Final Initial Study and Mitigated Negative Declaration

PacifiCorp
Lassen Substation Project
(Application No. A.15-11-005)

May 2017

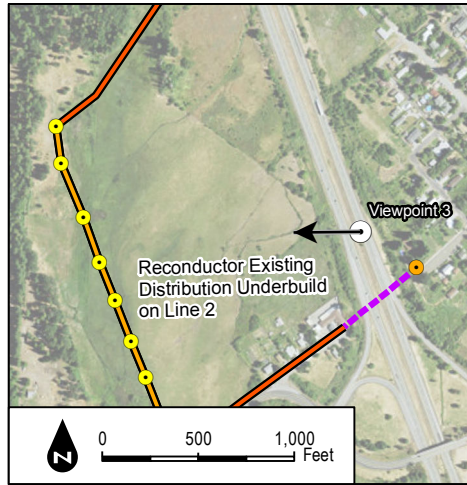
B3-5 The commenter states that Figure 5.1-8 does not provide an adequate comparison of the visual impacts to be expected by the project, but does not include specific

- comments regarding the inadequacy of the figure images. Figure 5.1-8 presents an existing view and simulated view of project components (located approximately 0.25 miles away) from the northbound travel lane of I-5, approximately 0.35 miles north of the West Lake Street Overpass. As discussed in the IS/MND, Figure 5.1-8 and Viewpoint 3 present a representative view that is available to passing I-5 motorists and project area residents located within the middleground distance (i.e., 0.25 miles to 0.75 miles) of the existing 69-kilovolt transmission line.

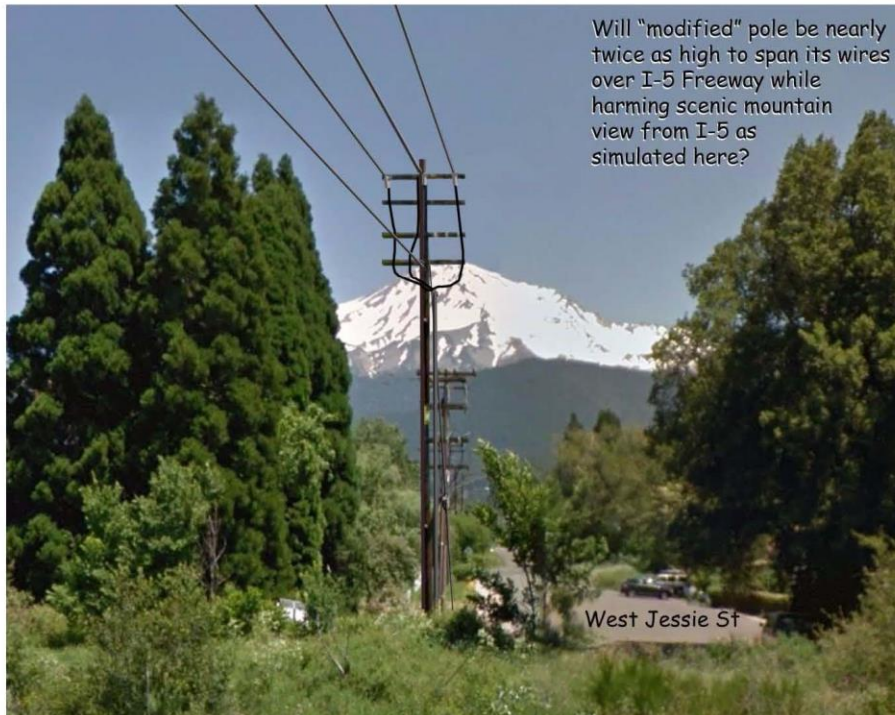
a. The PEA Fails to Disclose the Significant Visual Impact of Newly Proposed Overhead Power Lines and Taller Power Poles and Transformer.

This picture below is a simulated view of this overhead power line part of this PacifiCorp/Crystal Geyser Project where it will connect to a modified power pole on the east side of the I-5 Freeway at the end of West Jessie Street:

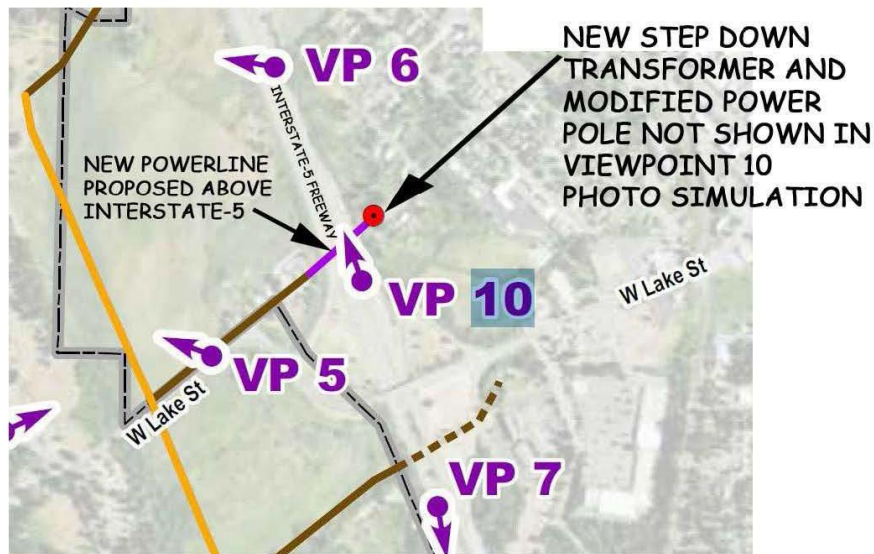
CEQA requires an Environmental Assessment to provide baseline data, such as in the case of power pole replacements, existing heights and diameters. The public is unable to independently evaluate whether the proposed Project's visual impacts will be significantly adverse without being given critical data upon which to assess the visual changes. One cannot tell if the visual simulations presented in the PEA are accurate or if the Project's visual impacts are being minimized with the use of erroneous photo simulations.

For example, in the PEA's simulated photo comparison for Viewpoint 10 (a view to the north from Northbound I-5), no new power poles are shown for the proposed New Overhead Circuit that will

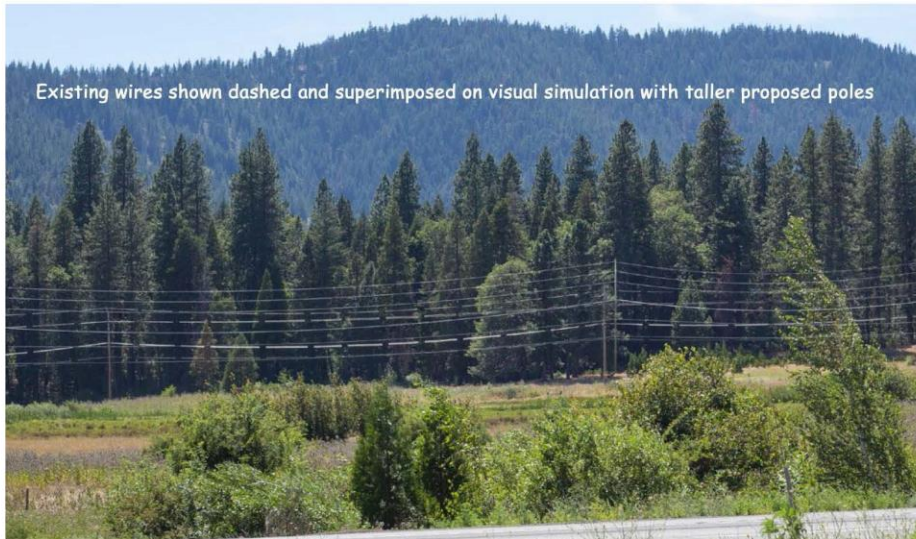
4. The PEA's Visual Impact Analysis of Prominent Mountain and Meadow Views to the West as Seen From the I-5 Freeway is Inconsistent and Deceptive.

The PEA provides an "existing" and a "proposed" view of the new power poles and conductors seen to the west of the I-5 freeway. But in spite of the PEA's claims on page 62 that such visual simulations are *accurate* because they were prepared using a variety of sophisticated software programs, ordinary people can look at the visual comparisons as presented and with some effort see that the proposed Project views are neither accurate nor consistent with the text in the PEA.
